FSCF Pending Changes into Final Design

Slides from Arup Final Design Kick-Off Meeting (11/7/17)

April 11, 2018

Current Rock Septum details

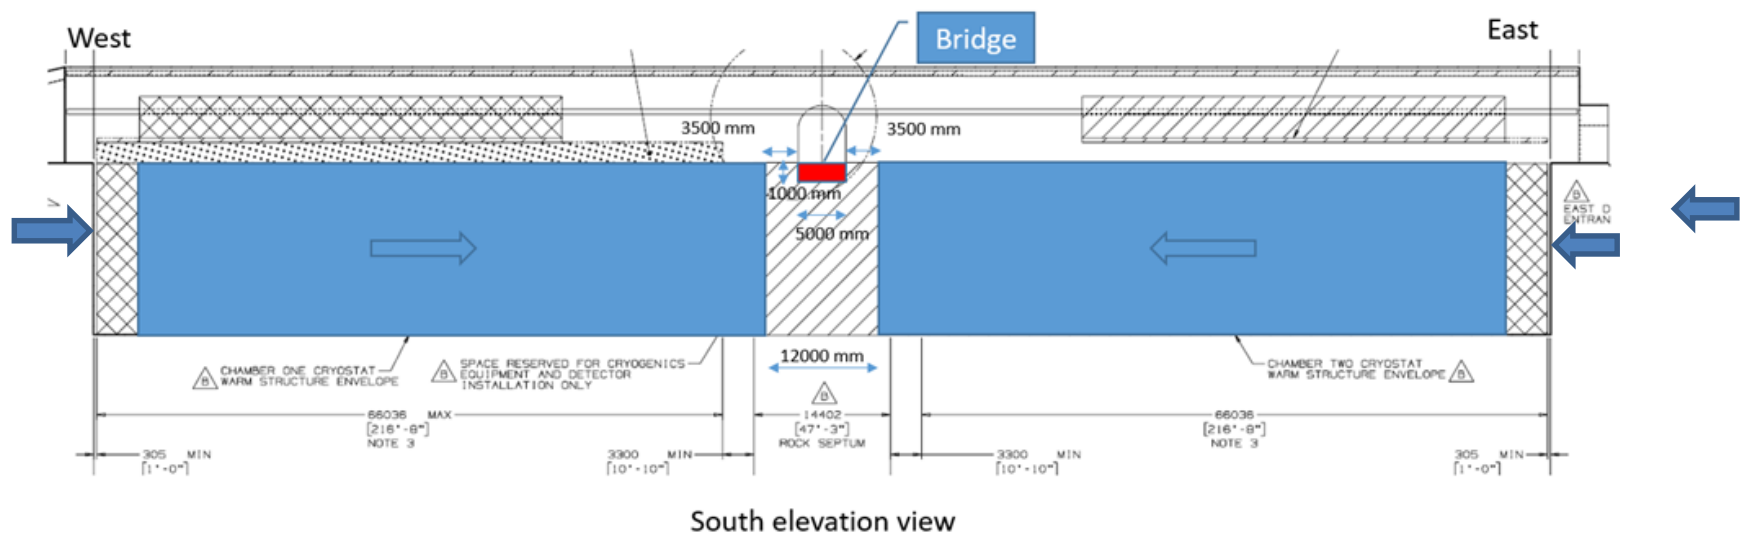
Scope of change

- Remove rock septum down to 4910 level (?)
- Move east CS 4.5 m to the west, and west CS 4.5 m to the east, reduce overall cavern length by 9 m.
- Build 5.00 m (?) wide bridge between north and south drifts
 - Bridge capacity to allow industrial equipment passage (?)
- Route all “crossing” utilities below bridge to allow continuous monorail/bridge operation
 - Does this section of monorail need to be removable (?)
- Moves the cleanroom (supported by bridge (?)) for detector installation below the 4850 level to liberate the space above. This reduces the interferences with overhead conveyances, rack installation and materials moving into the CUC.
- Cranes below bridge for assembly supported by bridge (?)

More views with rock septum removed

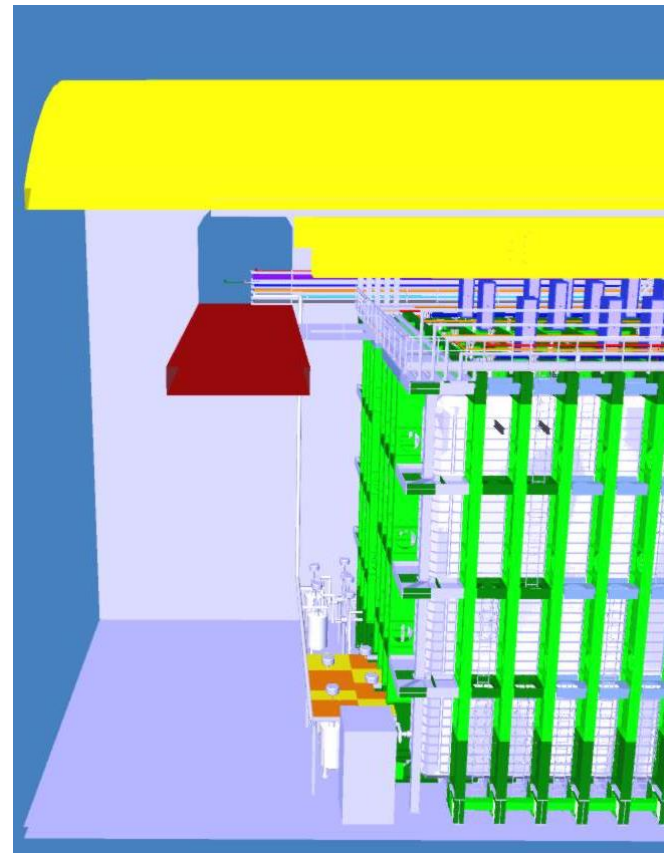
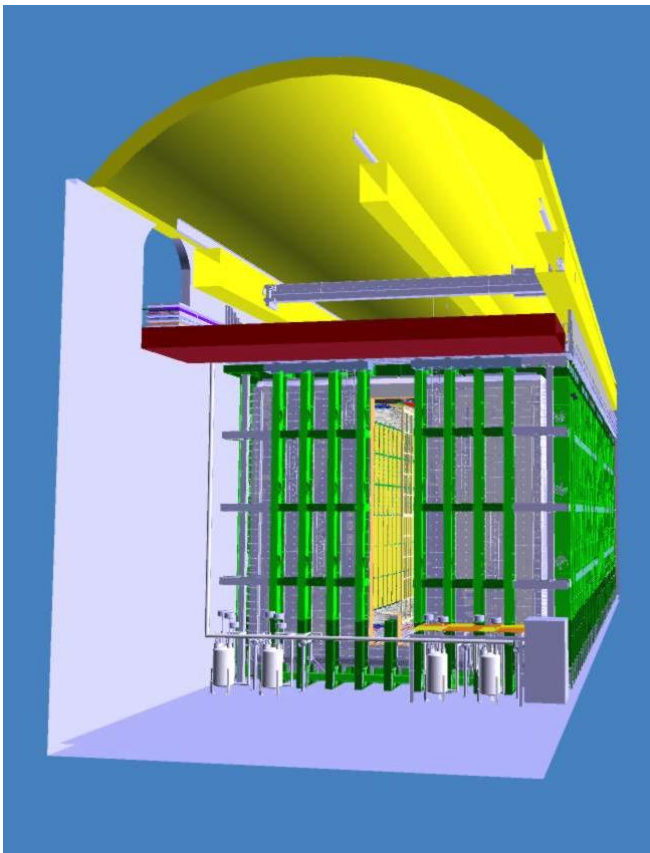
- Where do we add vertical access, and in what form (stairway vs. Alimak style, temporary vs. permanent) (?)

Hoists and cranes

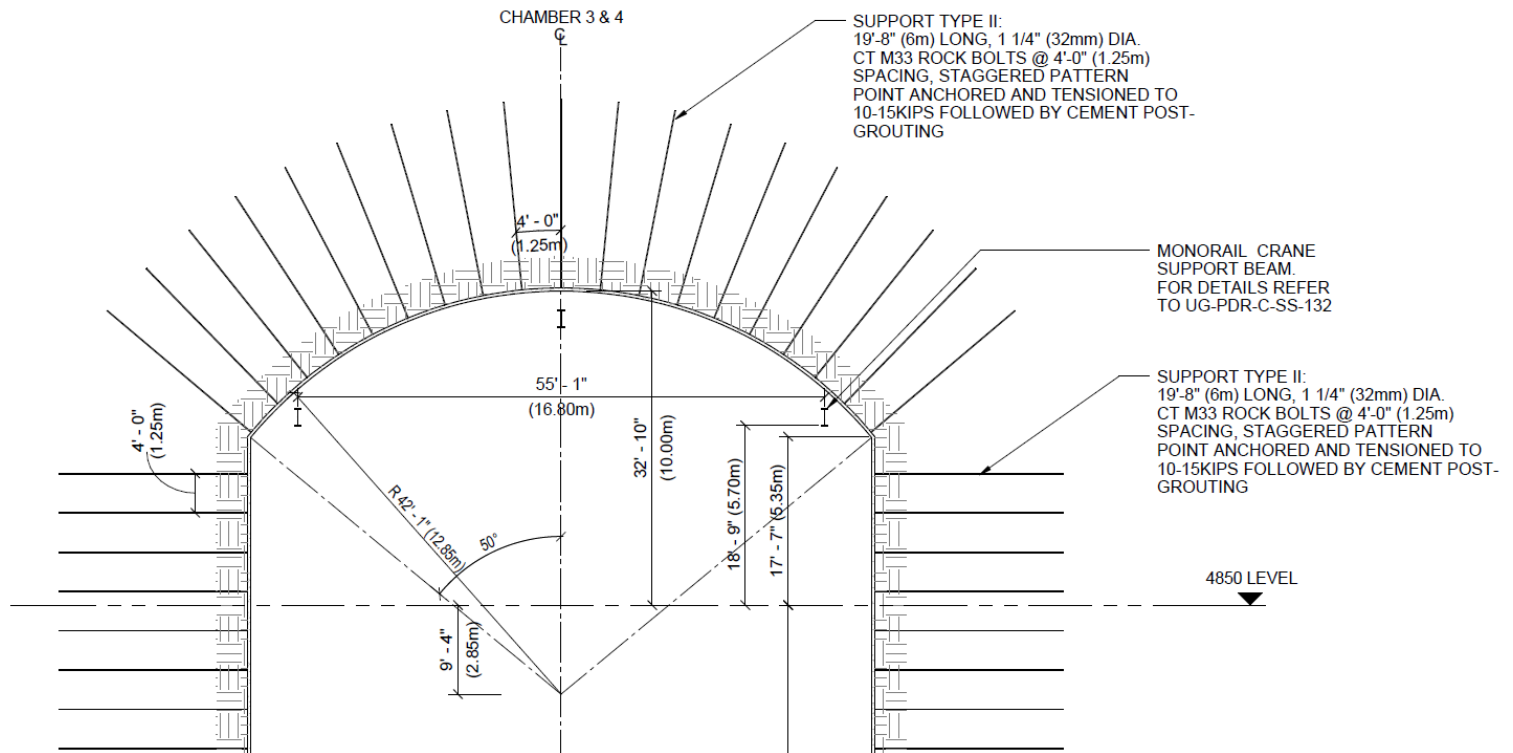
- Bridge crane – full width (?), half width (?), both (?), how many (?)
- Monorail hoists – how many per beam (?), design to handle full load adjacent to bridge or other monorail hoists(?)

Mezzanine

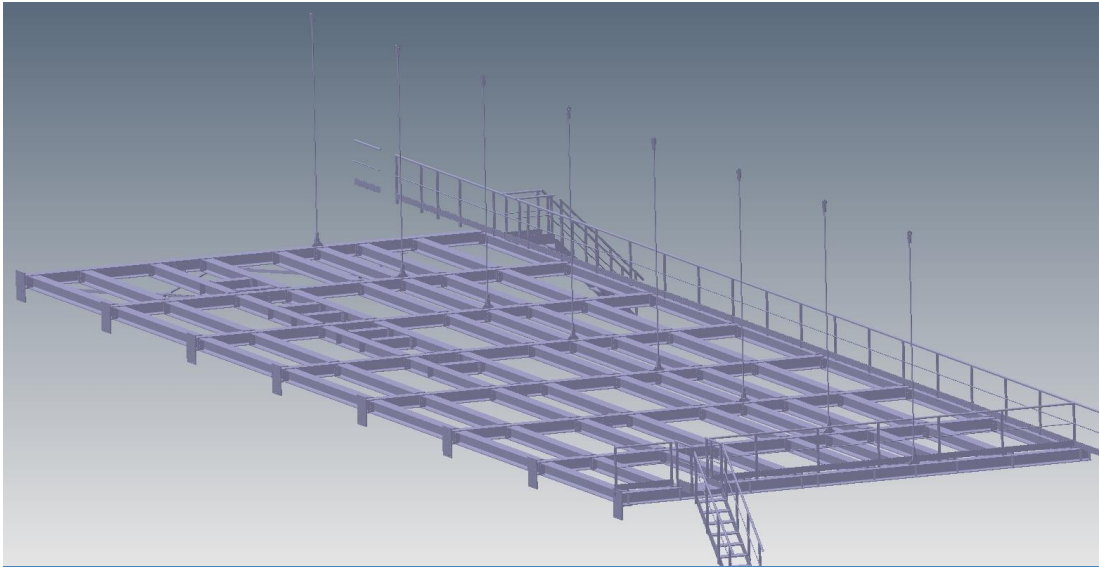
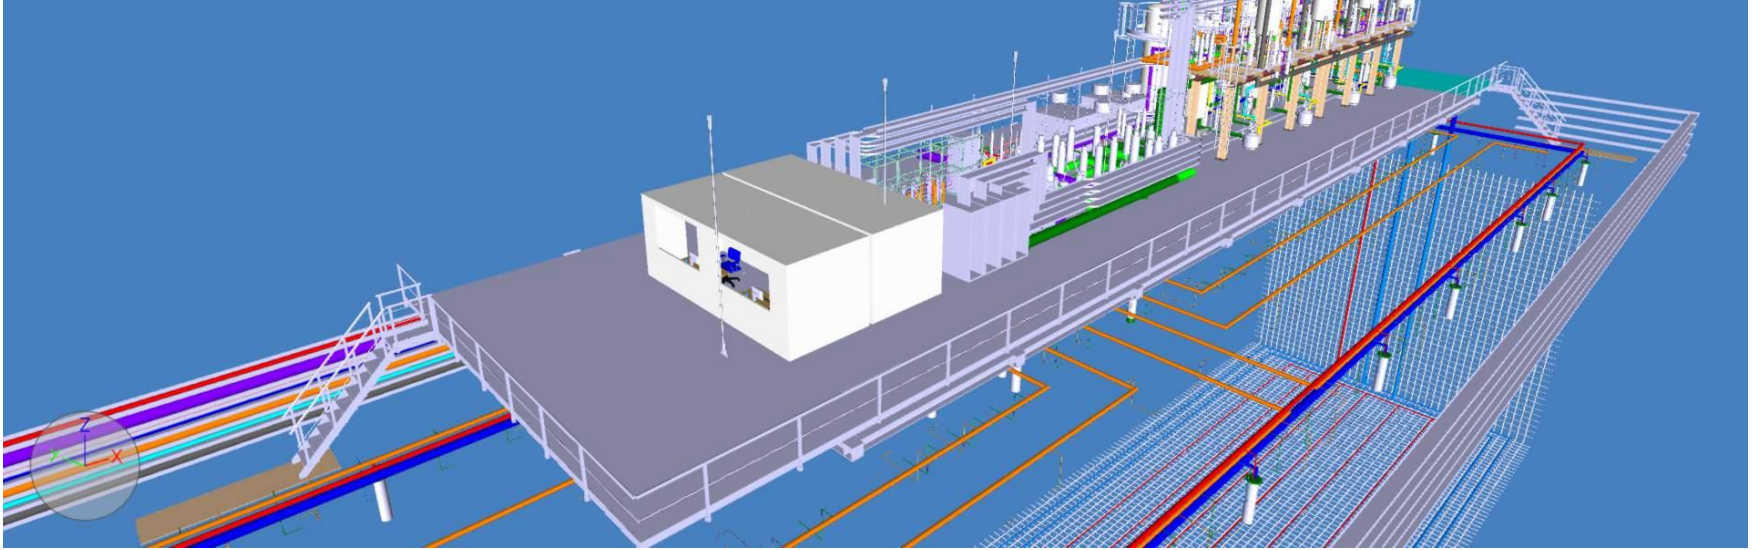
12.3m x 45m mezzanine

Arup to provide attachments
to crown and walls
